GATEWAY PORTABLES & SHADE STRUCTURES

Bid Clarification 01

September 21, 2026

DSA Application Number: 01-122796

C-2.1

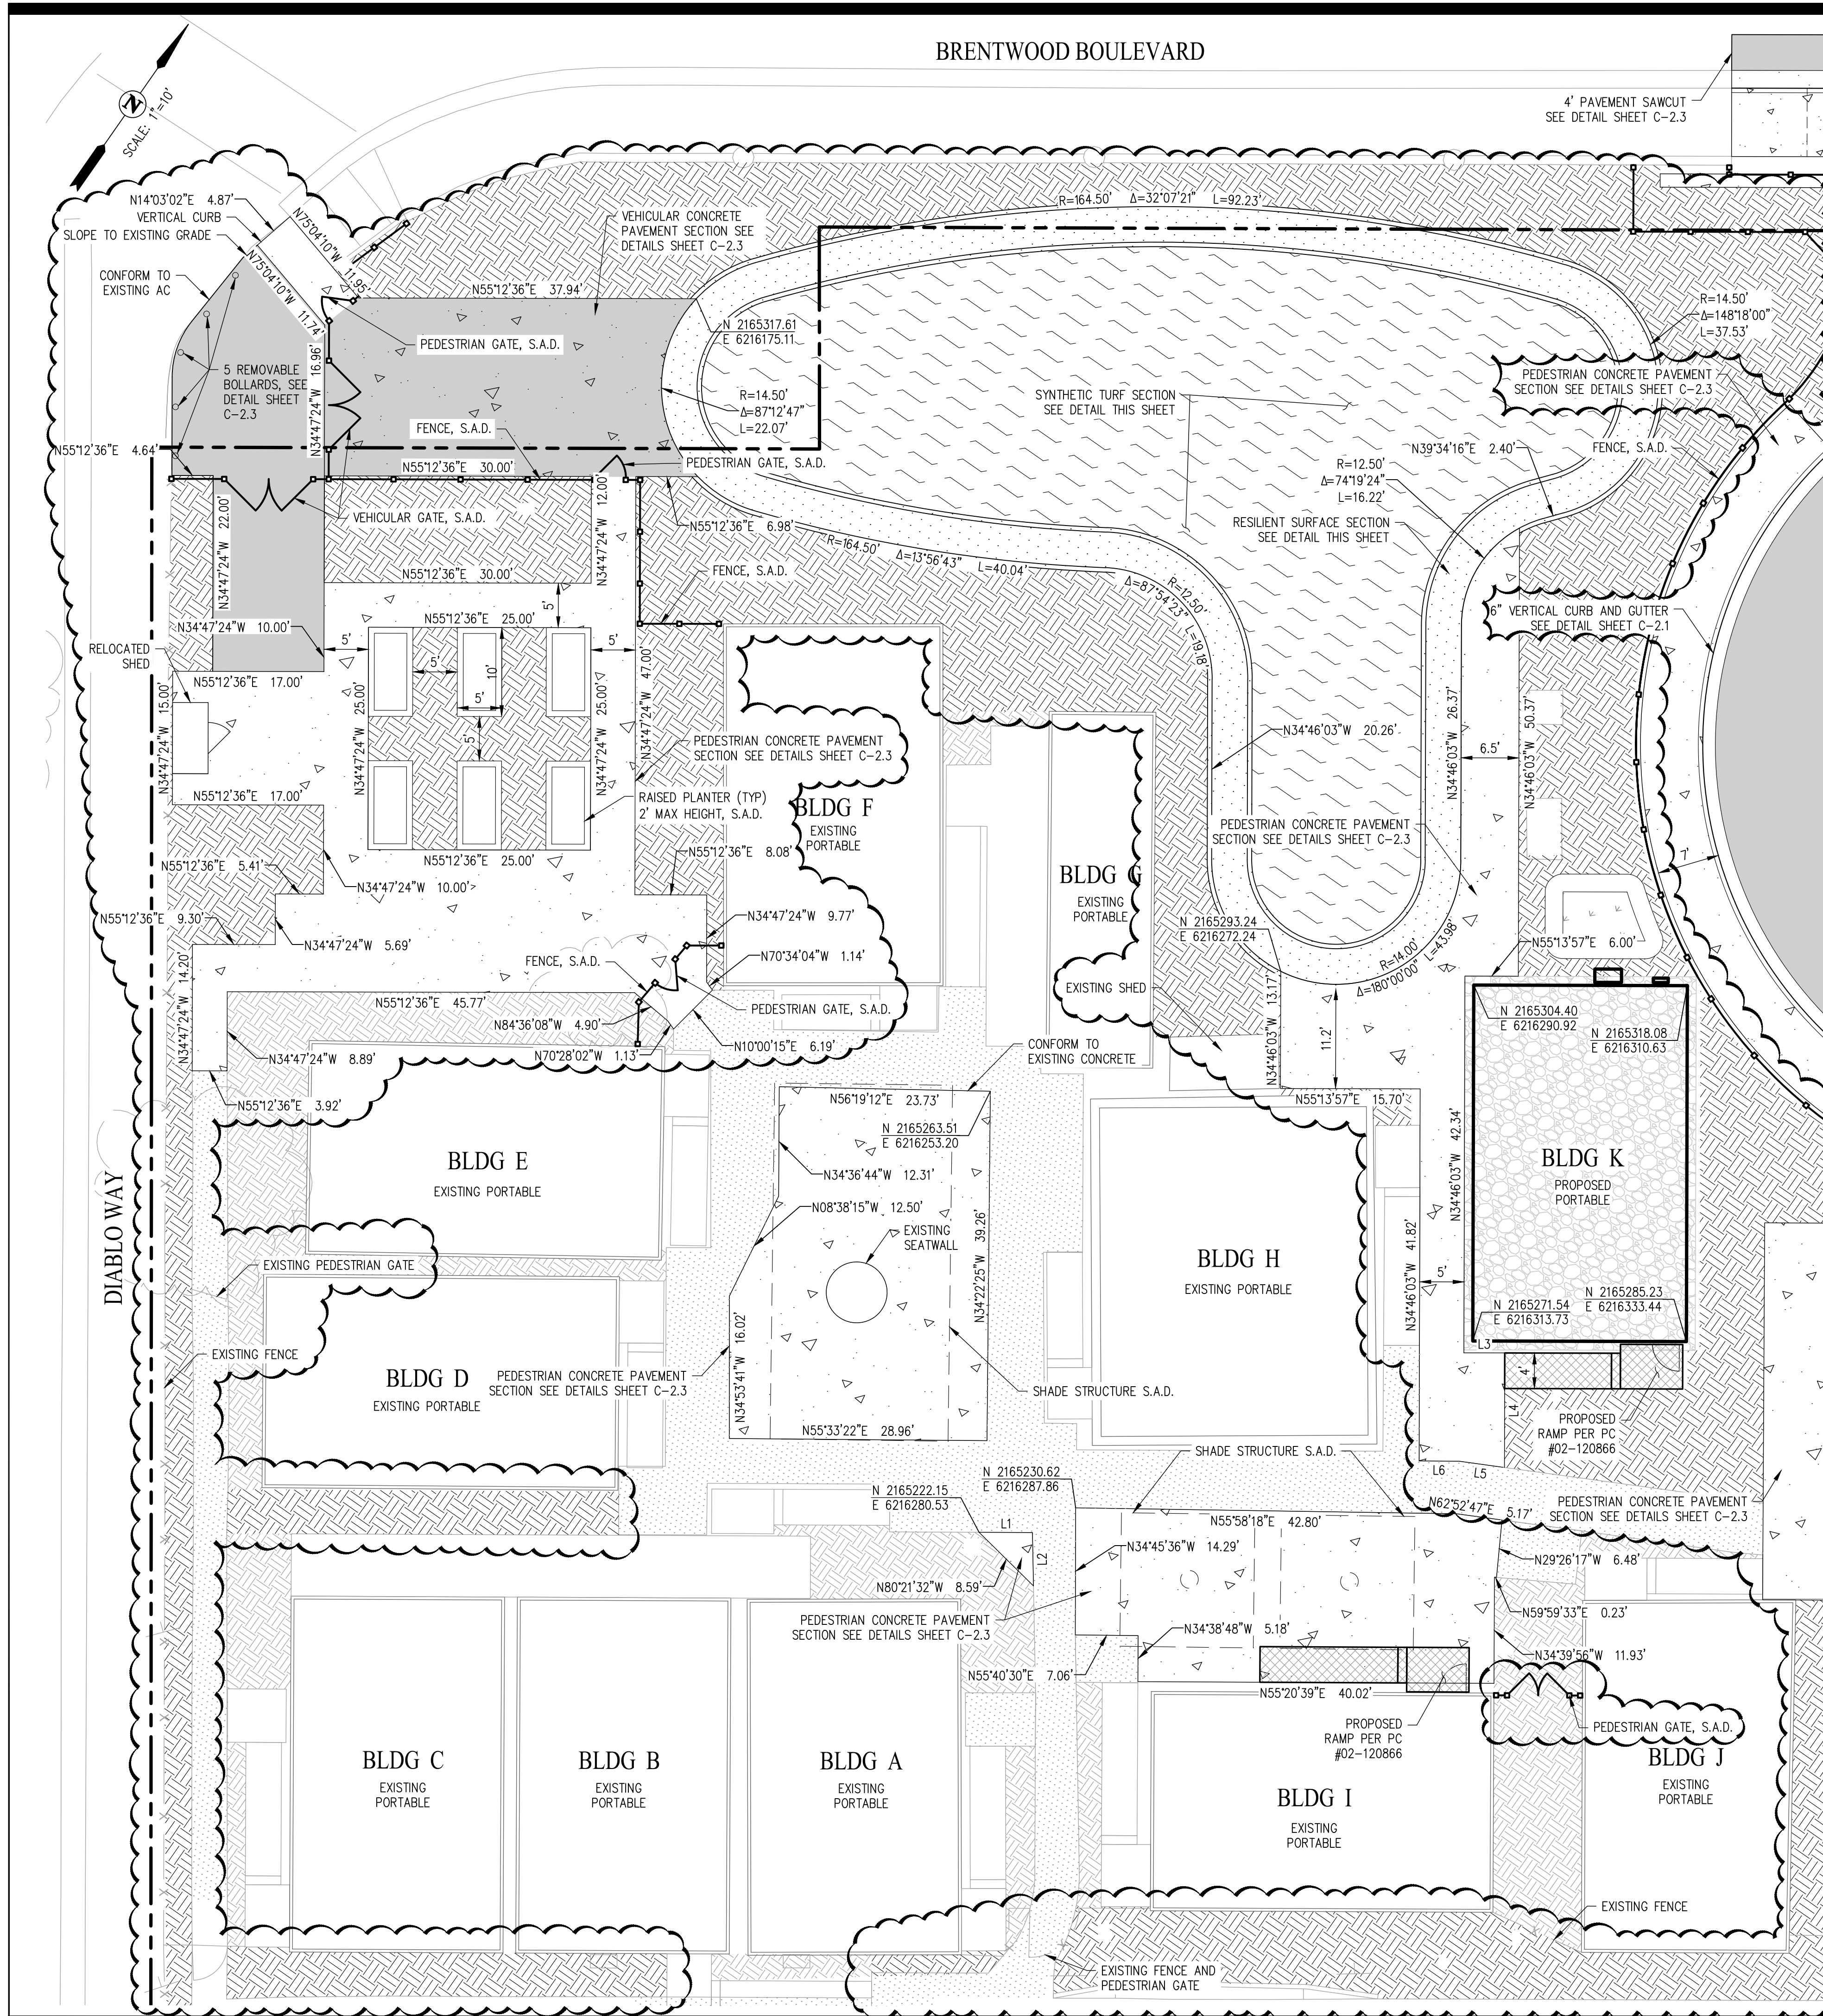
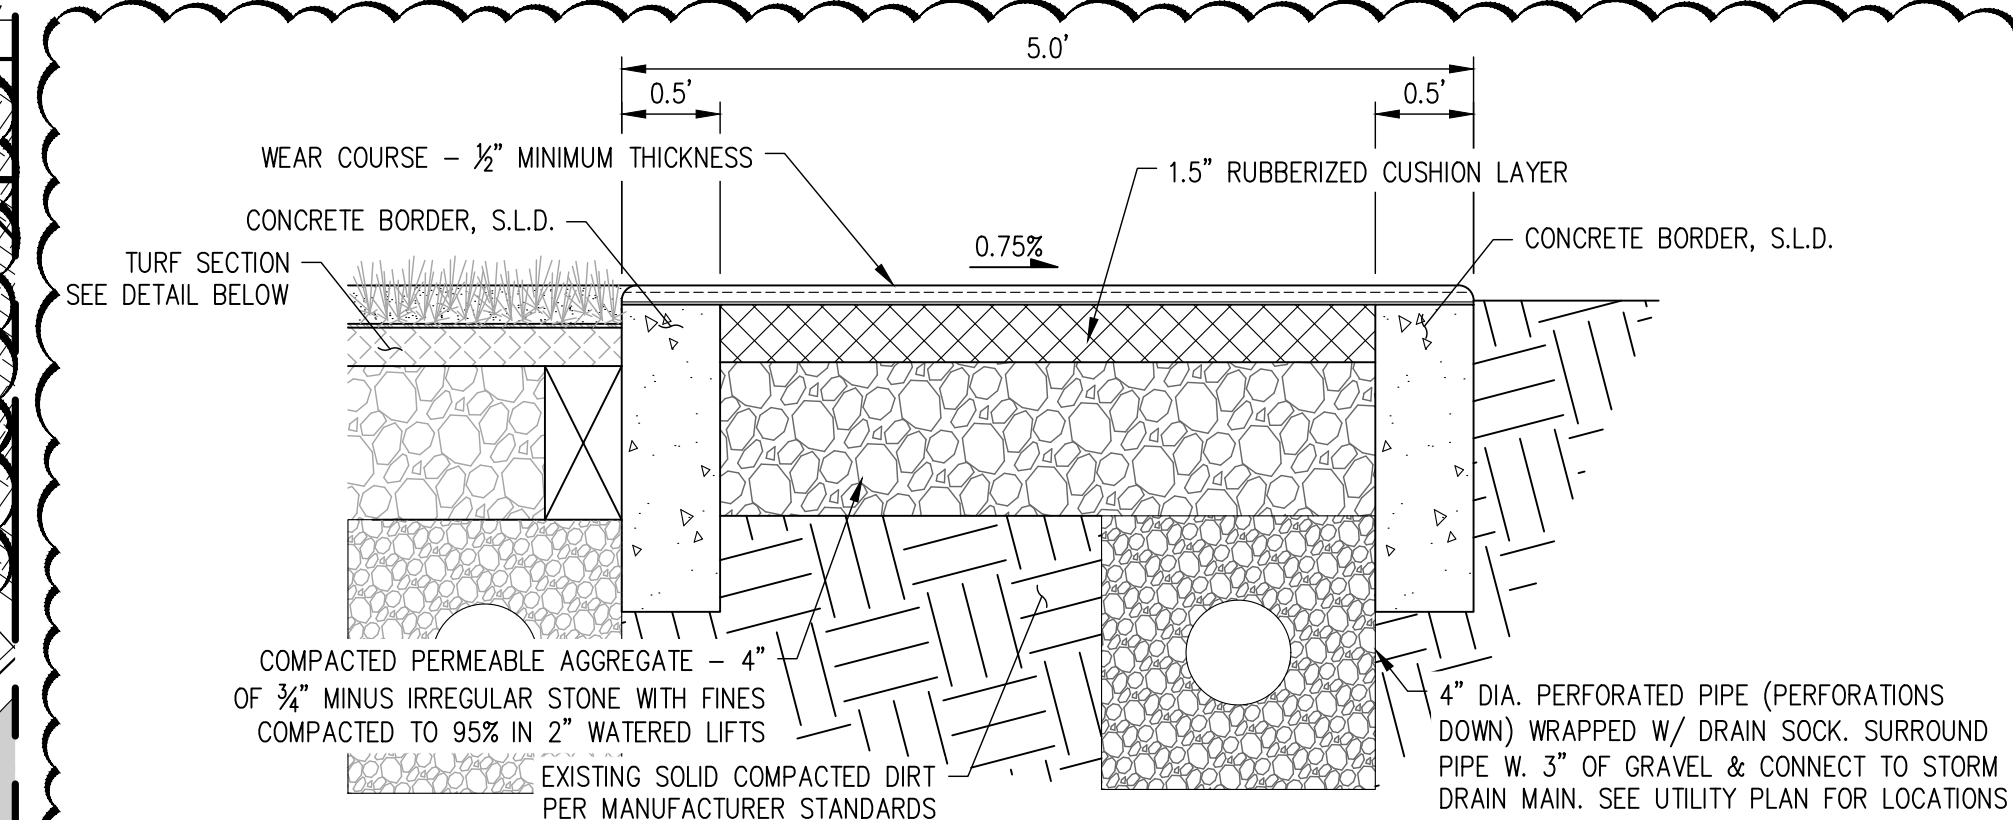
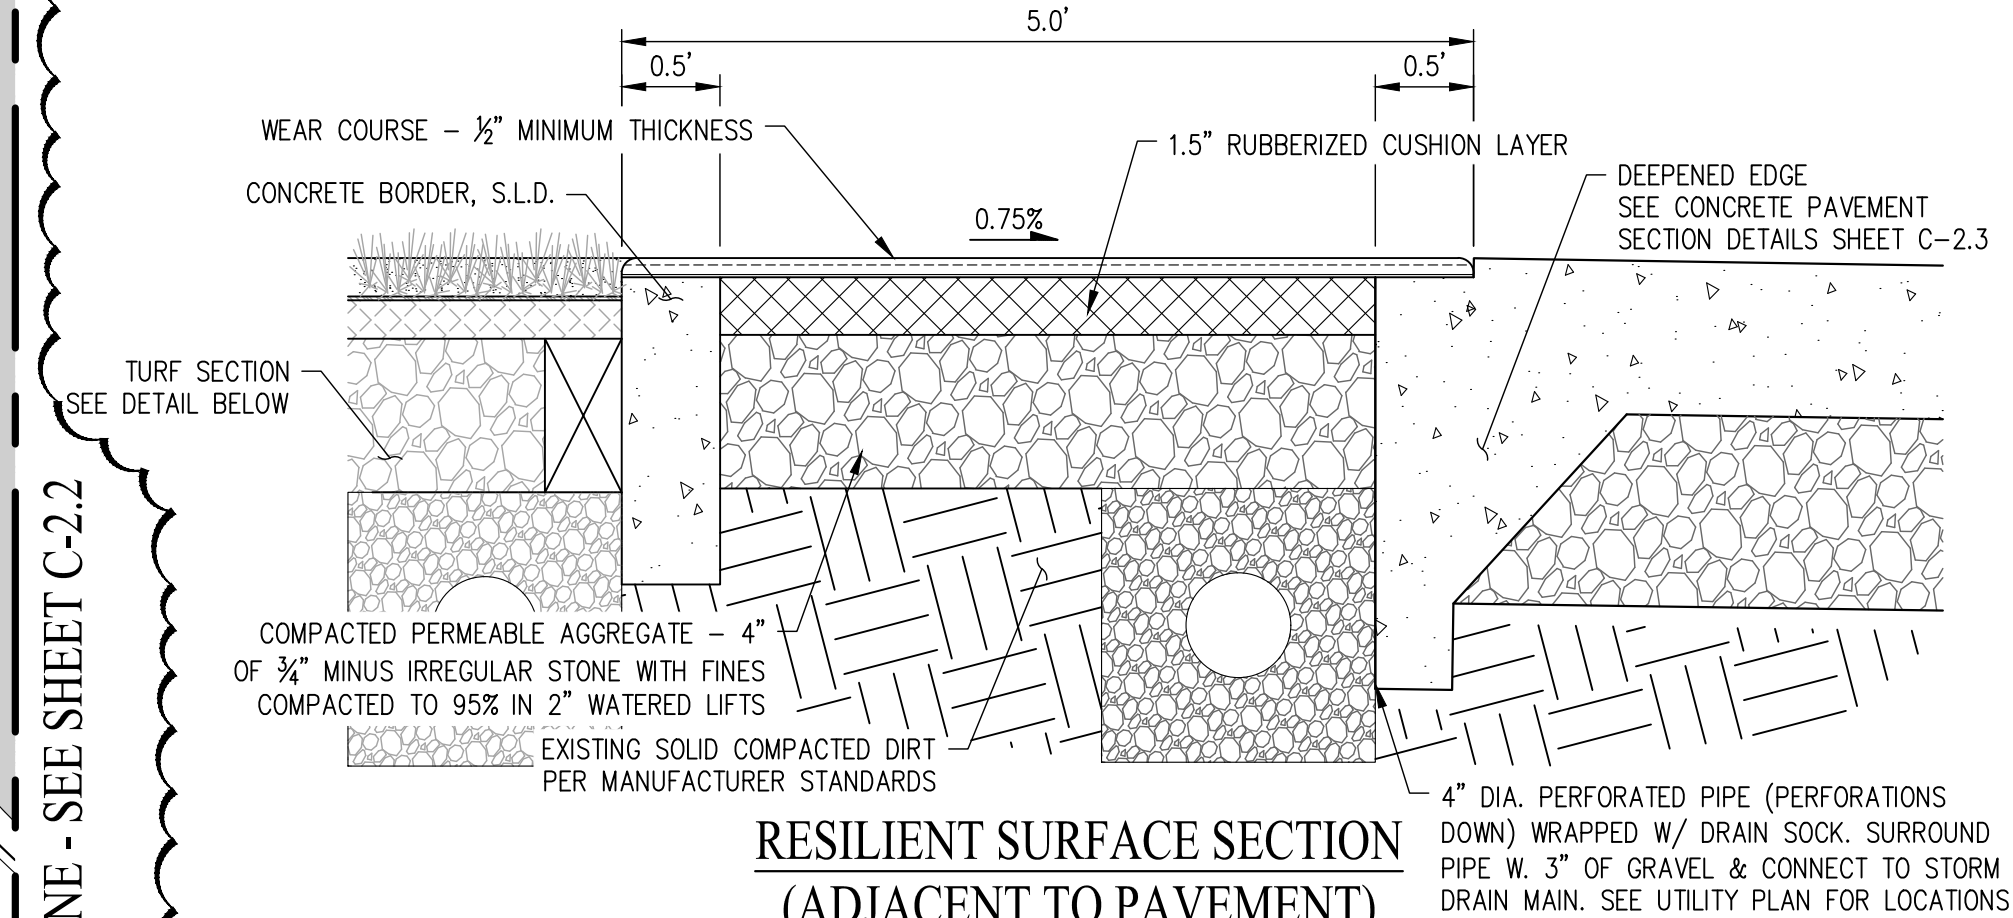
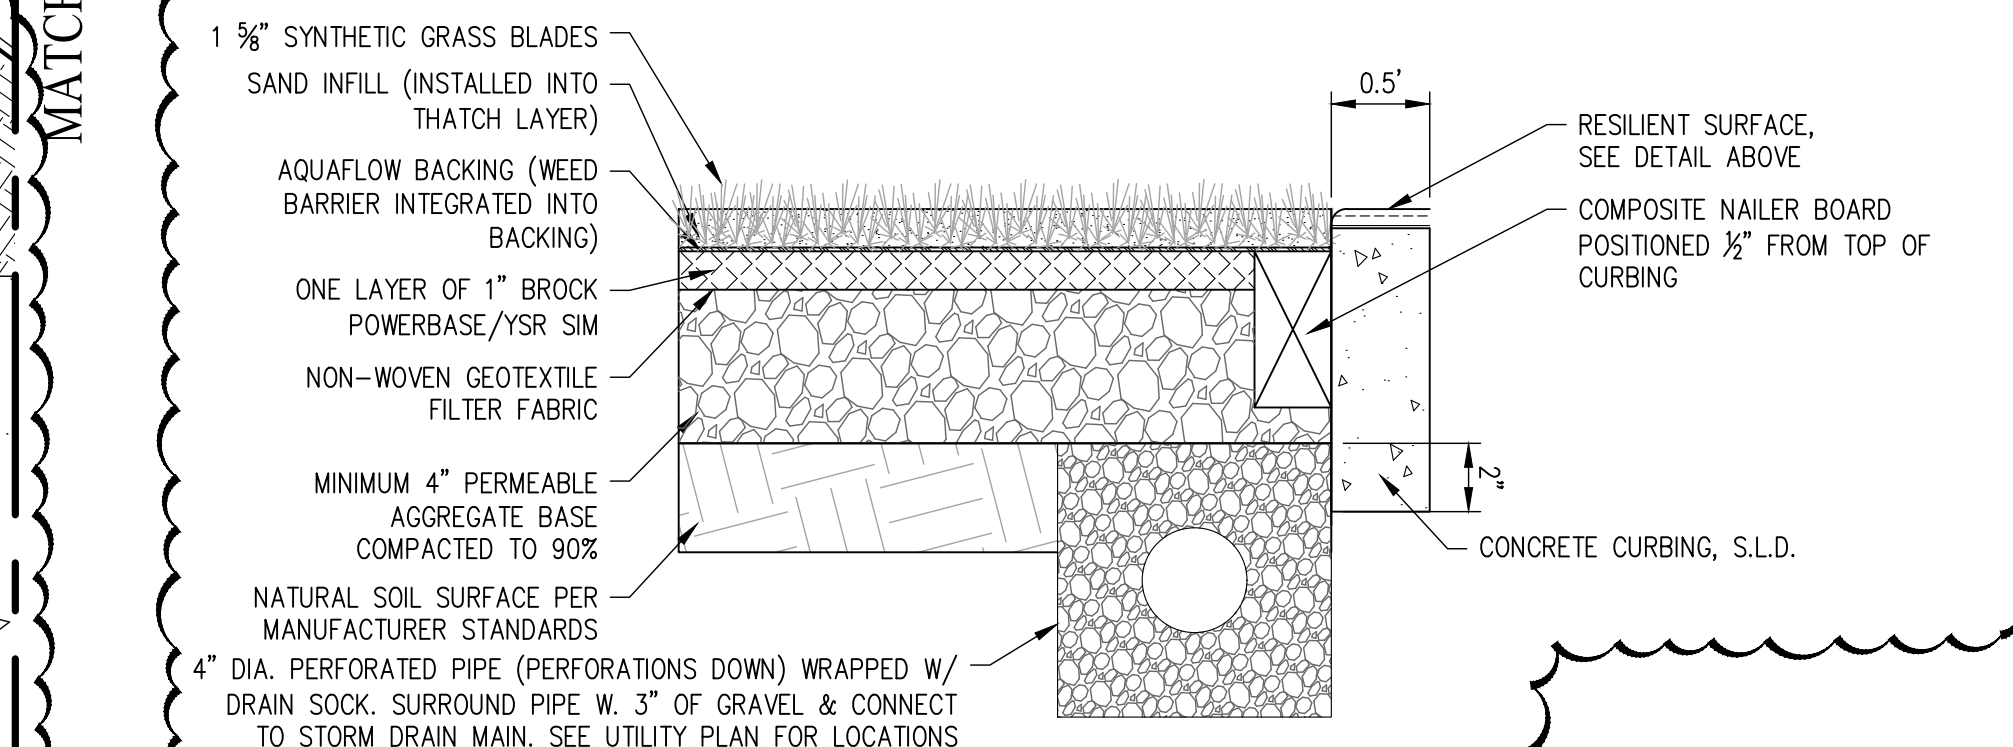
C-2.1 Horizontal Control Plan

- Horizontal Control Plan revised in its entirety reflecting the new site improvements.
- Details for Resilient Surface sections and synthetic turf sections added.

C-2.2

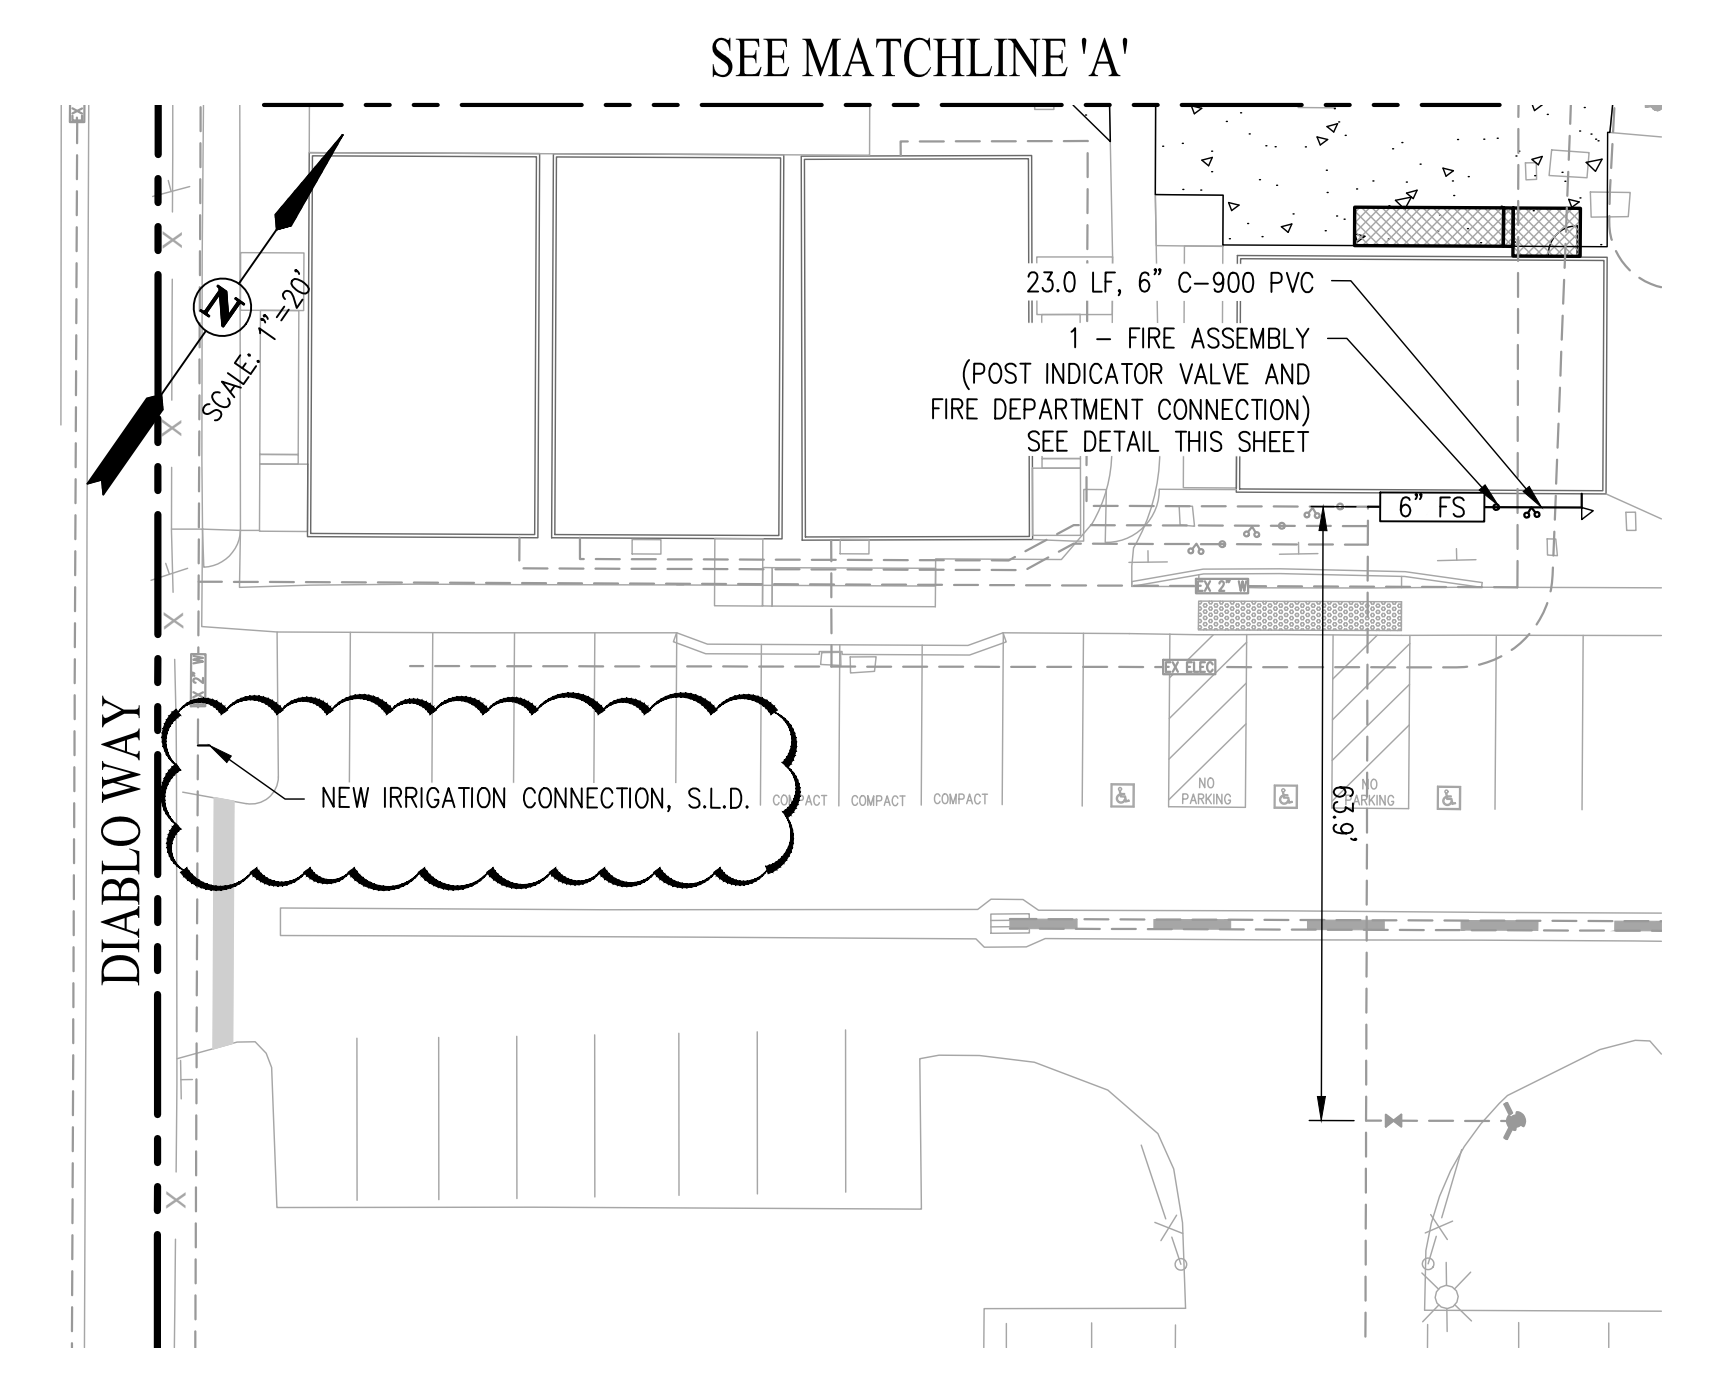
C-2.2 Horizontal Control Plan

- New sheet. Horizontal Control Plan revised in its entirety reflecting the new site improvements.
- Seat wall detail added.
